TEXAS UTILITIES GENERATING COMPANY  
SKYWAY TOWER • 400 NORTH OLIVE STREET, L.B. 81 • DALLAS, TEXAS 75201

FURTHER DATA REQUIREMENTS  
FOR ANALYSIS OF PROTECTIVE COATING  
BACKFIT INSPECTION PROGRAM

TEXAS UTILITIES GENERATING COMPANY  
COMANCHE PEAK STEAM ELECTRIC STATION  
G&H PROJECT NO. 2323  
PROTECTIVE COATING  
PRELIMINARY COATING EXEMPTION LOG

COMANCHE PEAK STEAM ELECTRIC STATION  
DESIGN CHANGE AUTHORIZATION

DCA NO. 3270 Rev. 3

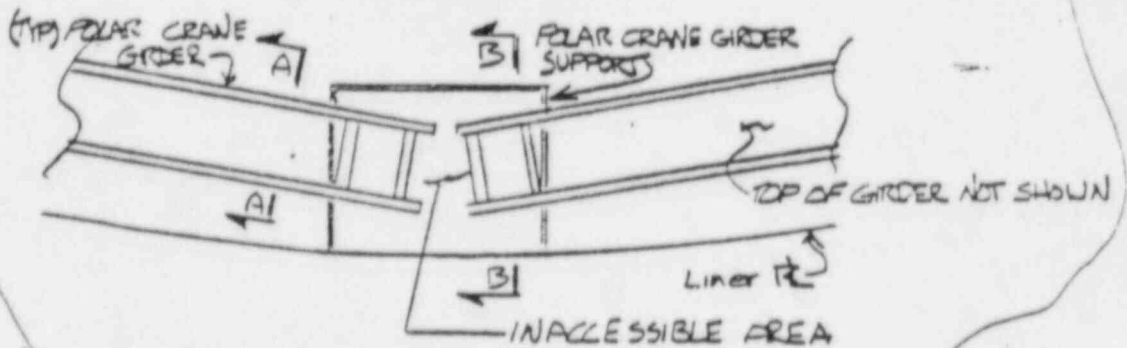
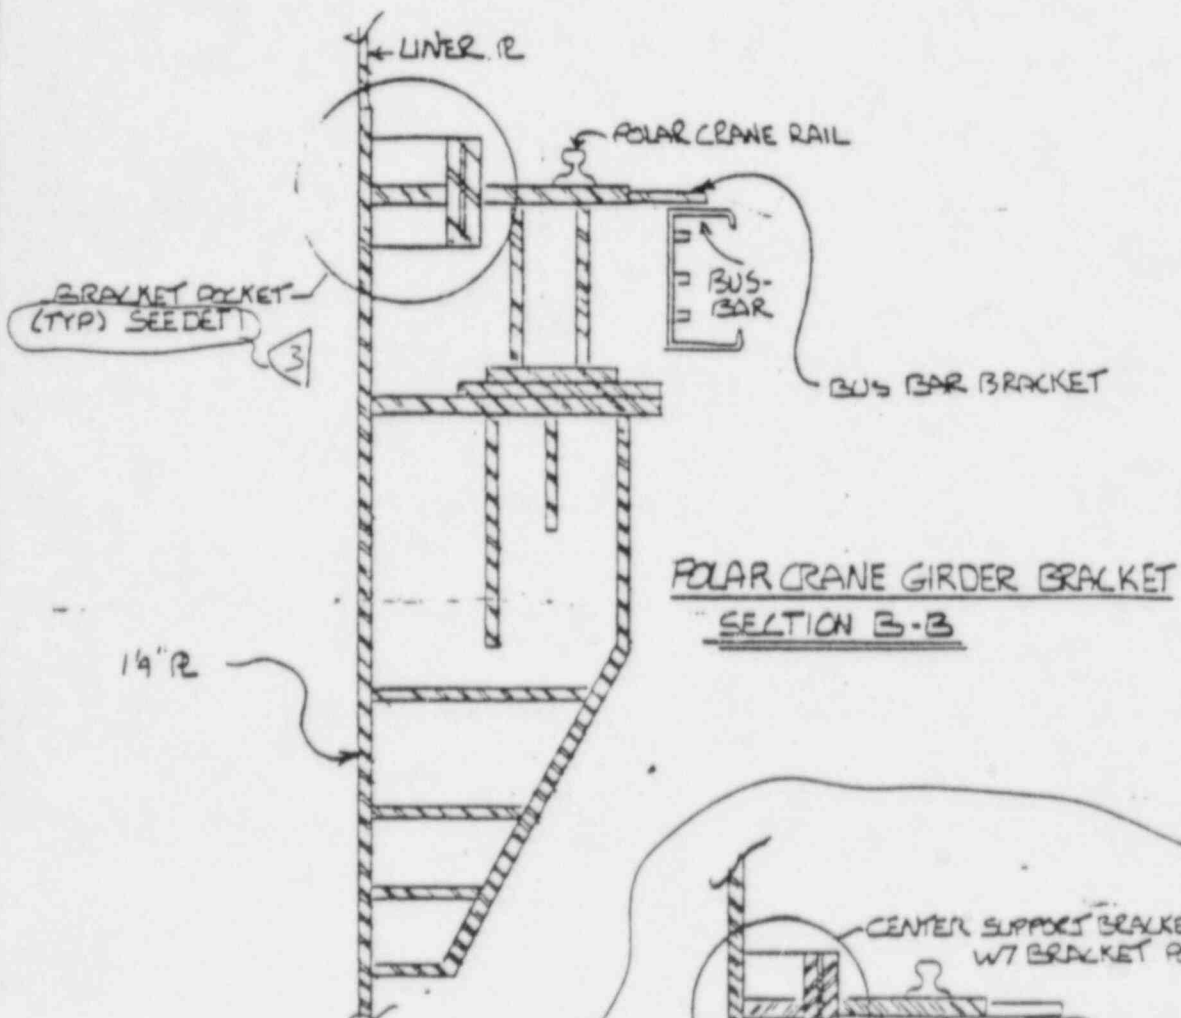
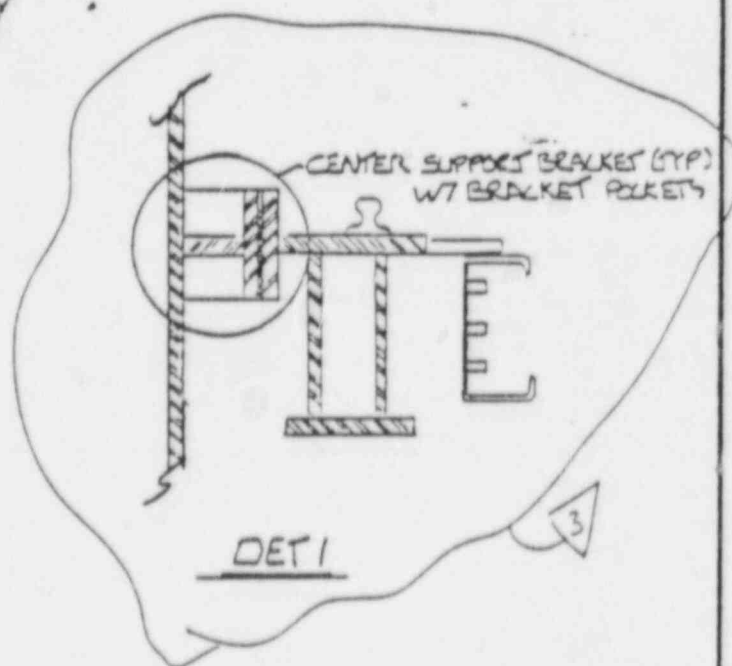
Request authorization to perform coating operations under specification 2323-AS-30 in Containment 1 & 2 @ Elevation 950'-7" to 947'-7" in the Polar Crane Girder area. Coatings encompass those applied to the back side of the Polar Crane Girders, i.e., liner side of Girder, coatings applied to girder bracket supports shown in section B-B of attached, coatings applied to the bus bar enclosure and behind the enclosure on the girder, and those applied to the bus bar brackets.

SOLUTION: Coatings applied to the area as stated above shall be under AS-30 guidelines with AS-31 specified coatings being utilized. The coatings shall be quantified and placed into the coating exempt log as referenced in section 1.1 of the above applicable specification.
